Planning Application 21/2758/FUL

'Design and Access Statement', part 4 of 13, pp70-74 Design: Town Square (3456754.pdf) 'Response to Additional Officer Comments' p.3-4 with reference to the Town Square/Event Space in the sections on Diamond Jubilee Gardens and Town Square (3446988.pdf) 'Applicant Response Covering Letter' p4 Landscape (3446987.pdf)

The Trust would like to offer clarification regarding the above statement, and also further clarifications made about the existing event space provided on Diamond Jubilee Gardens (DJG).

### Animal Magic event layout:

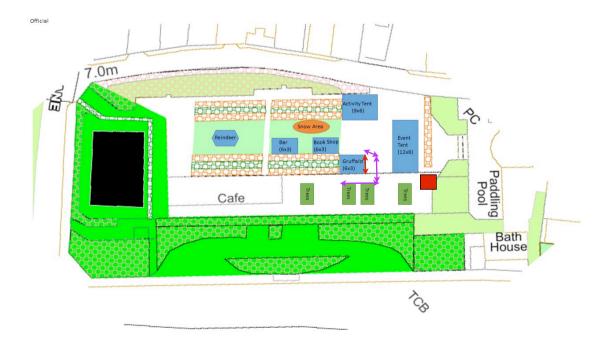
The Trust supplied DJG event layouts and photographs to inform the 2019 RIBA Design Brief, some of which are reproduced below. If planning officers wish to see more detail, this can be made available.
